CRYSTAL RIVER UNIT 3 NUCLEAR GENERATING PLANT

AMENDMENT TO FACILITY OPERATING LICENSE

Amendment No. 74 License No. DPR-72

ATTACHMENT TO LICENSE AMENDMENT NO. 74

3/4 9-12

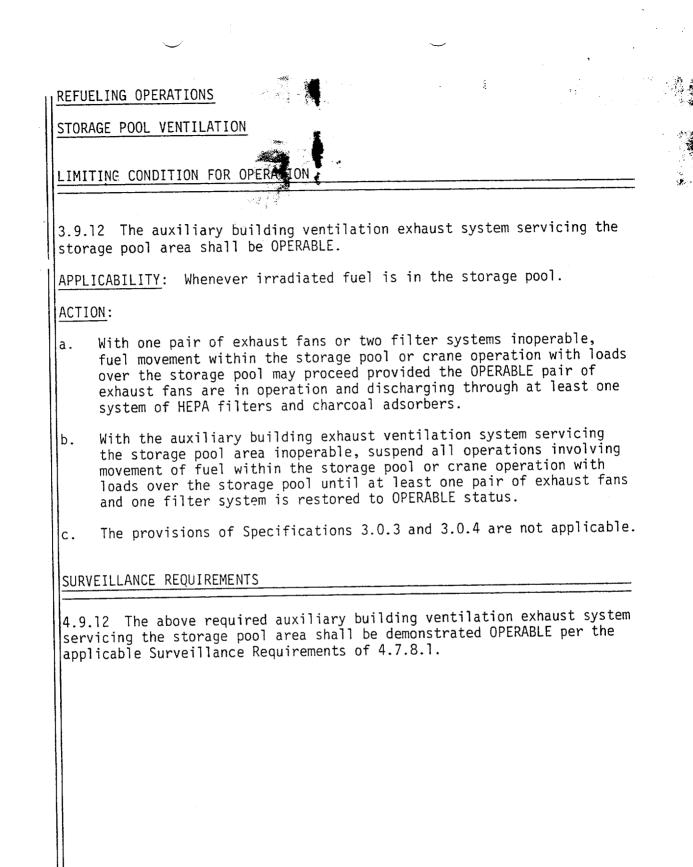
- a. With all missile shields not installed over the storage pool:
 - Immediately install all missile shields upon notification of a Tornado Watch, and
 - 2) Install all missile shields not required to be removed for in-progress handling of fuel assemblies.
- b. With the minimum water level requirement not satisfied, suspend all movement of fuel and crane operations with loads in the fuel storage area and restore the water level to within its limit within 4 hours.
- c. The provisions of Specification 3.0.3 and 3.0.4 are not applicable.
